## Product Change Notification

### PCN-IFC-7033-2021

Business Unit	Product Line Code	Type of Change	Action	Date of Issue
IFC - Industrial Field Connectivity	BF7	Product Change Notification	Notify Distributors and Field	8/20/2021

#### Description for Product Change Notification

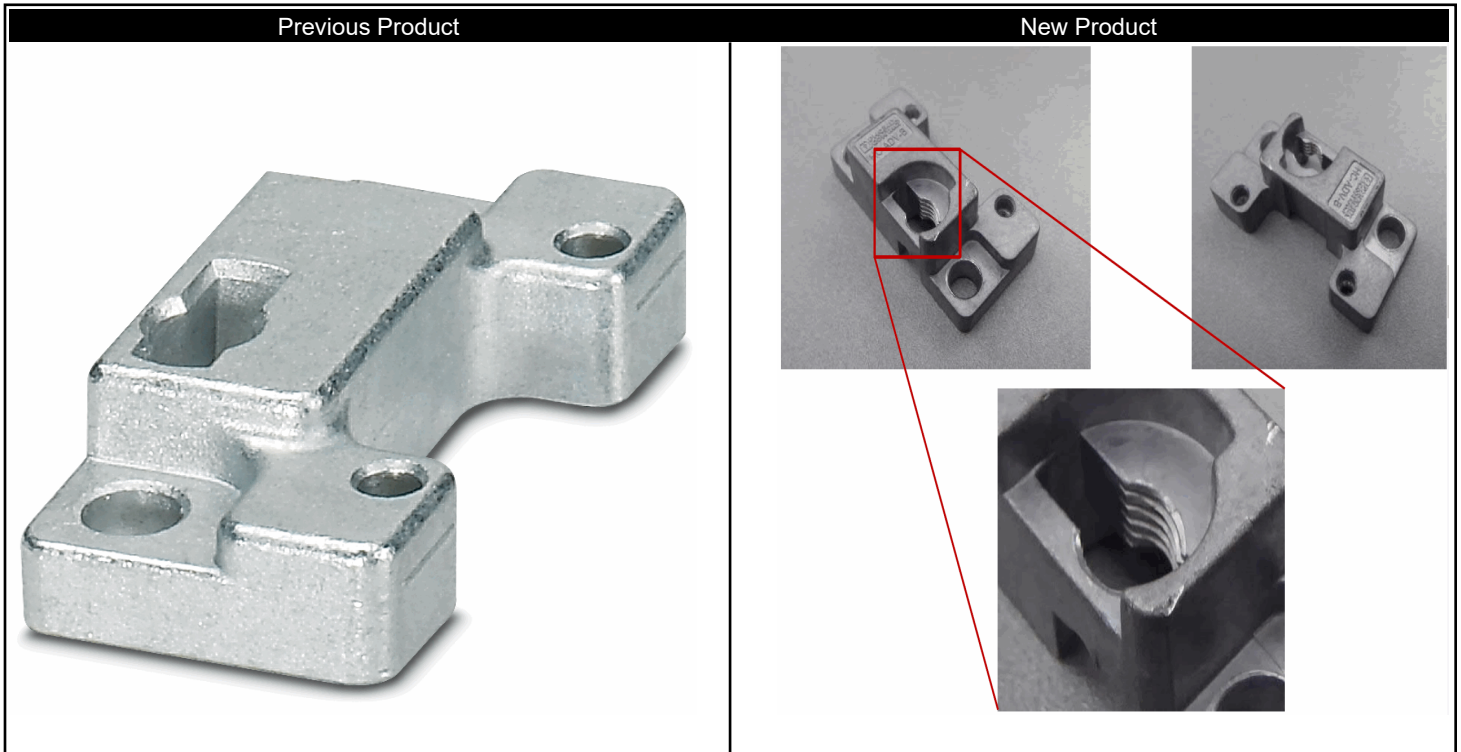
As part of the ongoing improvement process, the panel-mount flange developed for our HEAVYCON ADV bayonet housing has been upgraded. Now including an additional integrated thread, this new panel-mount flange allows for the option to use a protective cover with screw locking mechanism (among other covers), in addition to the version with bayonet interlock. The improved ADV bayonet panel-mount flange is made of die-cast aluminum instead of die-cast zinc, and is fully compatible with the previous version.
